LAND DEVELOPMENT TEAM (LDT) APPLICATION RESPONSE LETTER, SUBMITTAL # 5

PROJECT ADDRESS: 505 East Los Olivos Street
PLN RECORD #: PLN2024-00299
DATE: Thursday, July 3, 2025 – Review # 5
APPLICANT: Ben Eilenberg, THE MISSION LLC
socialindustrialequities@gmail.com
ASSIGNED PLANNER: Barbara Burkhart, BBurkhart@SantaBarbaraCA.gov
STATUS: COMPLETE

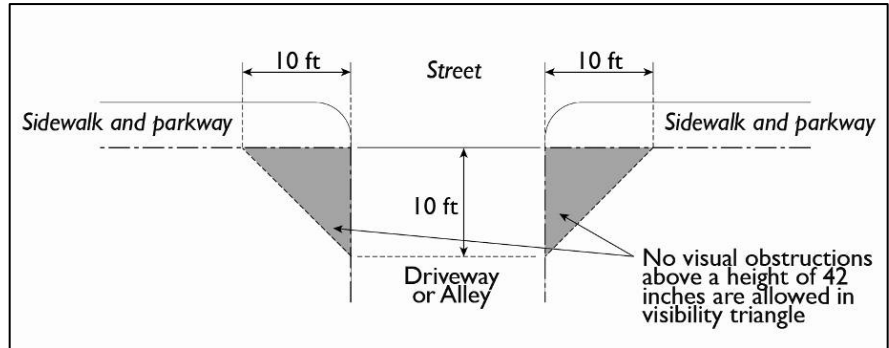
Show the Site Visibility Triangle per SBMC §[30.140.230](#), Visibility at Driveways and Intersections for the proposed development, including public improvements. ~~Your response letter indicates that this information is provided on the Civil Sheets, however it is not provided on any sheet in the plan set.~~ See below for further clarification on how to depict this on the plans.

- **SBMC §30.140.230.B Driveways.** Visibility at a driveway that crosses a front property line shall not be blocked above a height of 42 inches within the triangle areas described below:

- Street with Sidewalk and Parkway. When a driveway directly abuts a portion of a street with a sidewalk and parkway, the triangle is measured on two sides by a distance of 10 feet from the side of a driveway and 10 feet back from the front lot line.

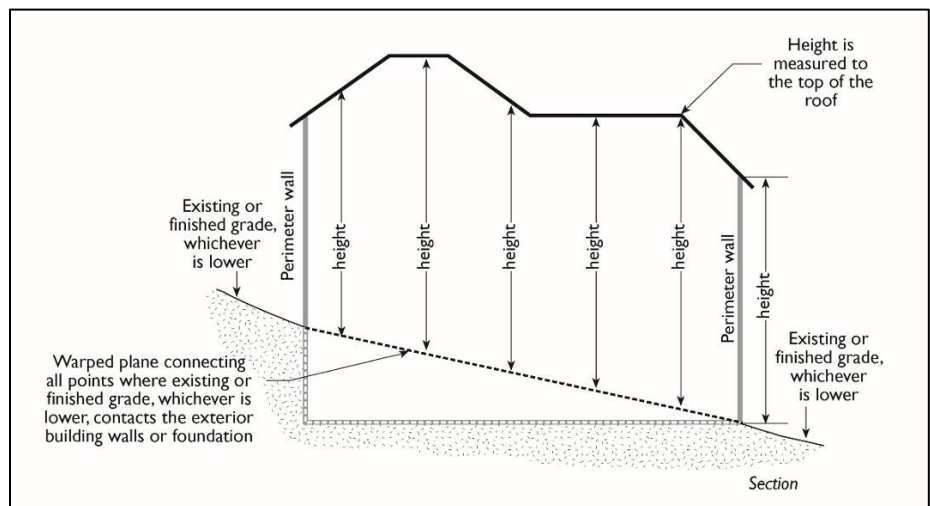
Identify building height on each elevation drawing and on any sections provided. Building height is measured from every point on top of the building roof or roof parapet to a warped plane directly below connecting all points where existing or finished grade, whichever is lower, contacts the exterior building walls or foundation system. See SBMC §30.15.090.A for additional information. Building heights are not dimensioned on Sheet A.2.02. Building heights on Sheet A.2.03 are not dimensioned for the elevation labeled, "Wing 2 – South Elevation," and are shown incorrectly on the right side of the elevation labeled, "Wing 2 – West Elevation." Please revise. Although building height was identified on the elevations, it was not shown correctly.

See below for further clarification on how to depict this on the plans.

- **SBMC §30.15.090.A. Measuring Building Height.** Building height is measured from every point on top of the building roof or roof

parapet to a warped plane directly below connecting all points where existing or finished grade, whichever is lower, contacts the exterior building walls or foundation system.

Figure 1. Floodplain and Floodway Outlines

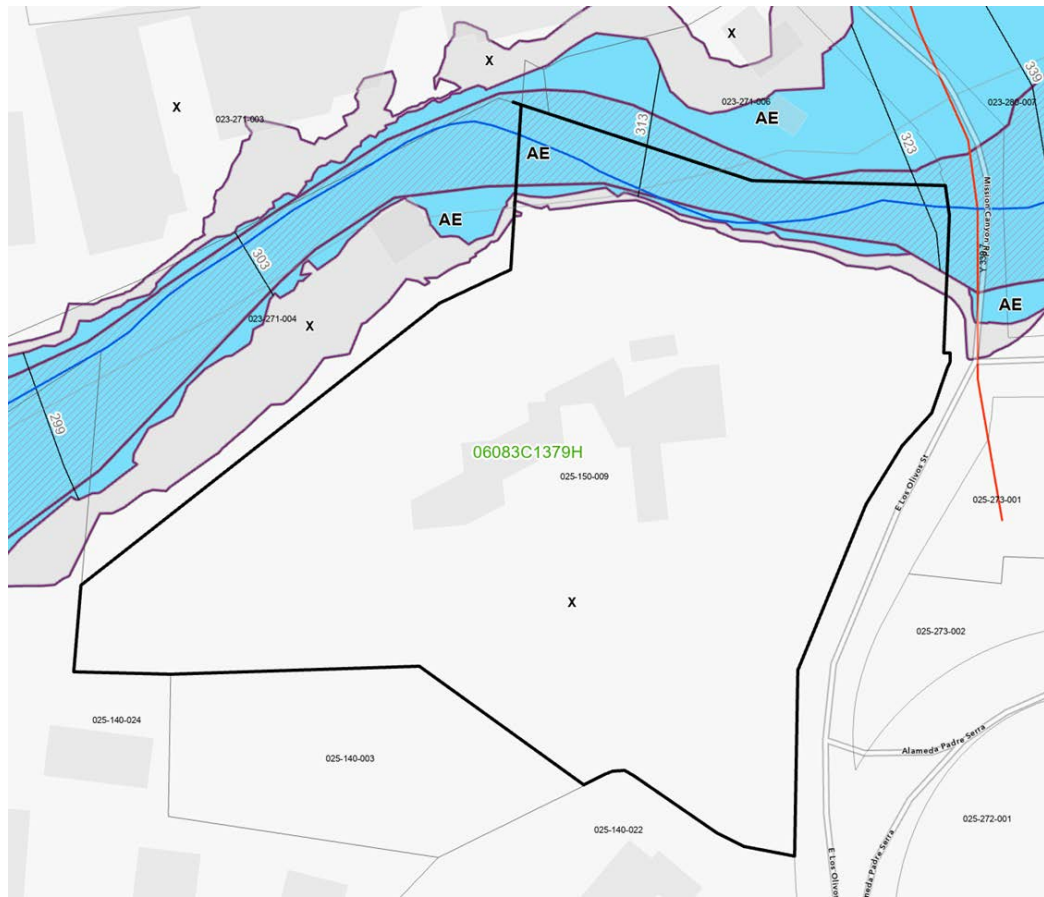
Provide a site civil engineering drawing locating the Regulatory Floodway and Floodway Fringe boundaries.

- b. Accurately show the AE floodplain and the AE floodway (hatched), as identified in Figure 2 below, on Sheet A.0.01. Identify all proposed structures, buildings, flat work, and site walls on this plan.
